Listed Building Consent

Reference: H14/0095/93 Received:12-FEB-93 Type:LISTED BUILDING

Description: General refurbishment, removal of front porch and bay window, demolition of small outbuildings
Location : The Former Five Bells Glenside North Pinchbeck Spalding

OLD FIVE BELLS, MONEY BRIDGE LANE, PINCHBECK - GRADE II LISTED BUILDING.

CANOPY ENTRANCE
DETAIL AS
PHOTOGRAPH

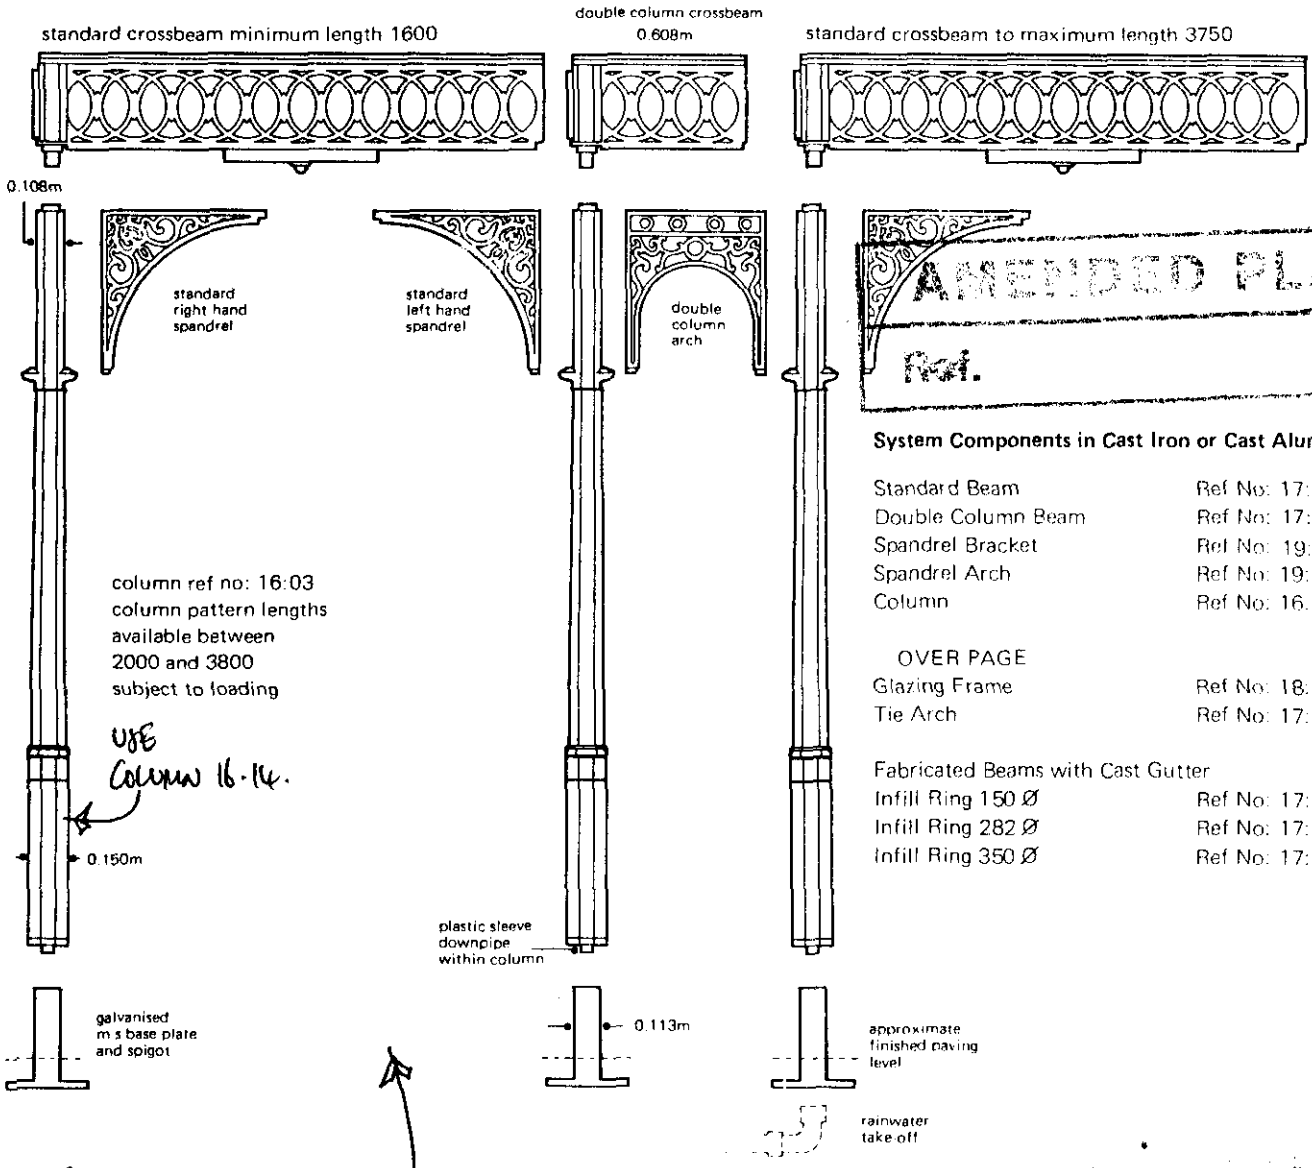
The porch chosen is not quite as I had anticipated, but it does provide a link between the railings and the house, and serves the purpose of giving some modelling to the facade. It also rather has the look of a pub or hotel entrance and so on balance I feel that it is acceptable.
